Date: September 6, 2007  
To: T10 Technical Committee  
From: Alvin Cox ([alvin.cox@seagate.com](mailto:alvin.cox@seagate.com))  
Subject: SAS-2 6Gbps PHY Electrical Specification

Abstract: The attached information defines the electrical requirements for 6 Gbps transmitter devices and receiver device. In addition, updates include reference transmitter and receiver device definitions to provide a means of determining if a channel is compliant and a cable specification section with requirements for 6Gbps usage. This proposal is a continuation of 07-063, at it ran out of revisions available.

**Figure 118 — Transmitter device common mode voltage limit**

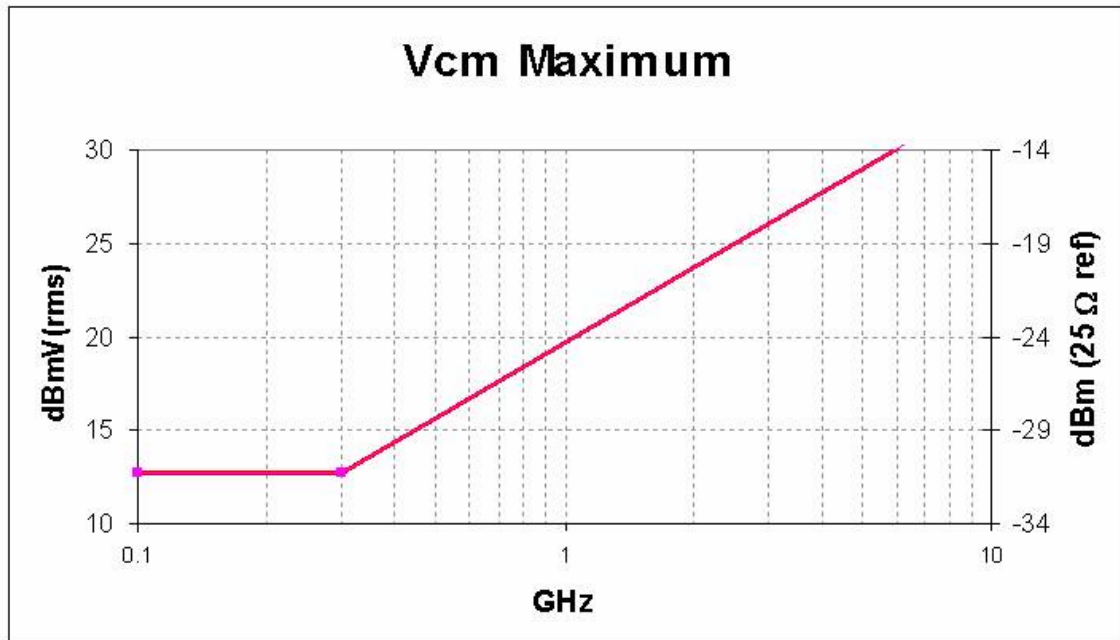
Flat line at 26 dBmV. No. Need more data.

Range of 100 MHz to 6 GHz?

What data pattern?

Measured with 1 MHz bandwidth.

**Figure 125 — Reference receiver device**

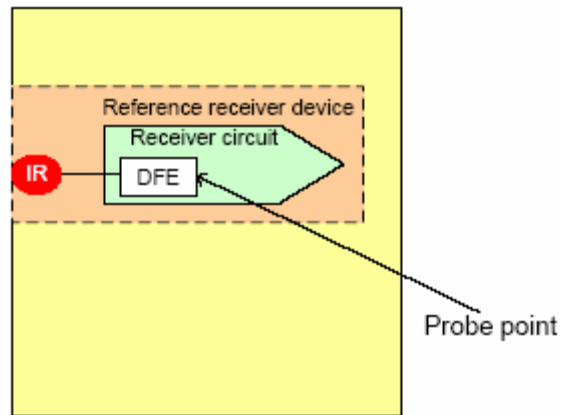
**Need vertical and horizontal opening requirements to meet BER. Tbd and .4UI?**
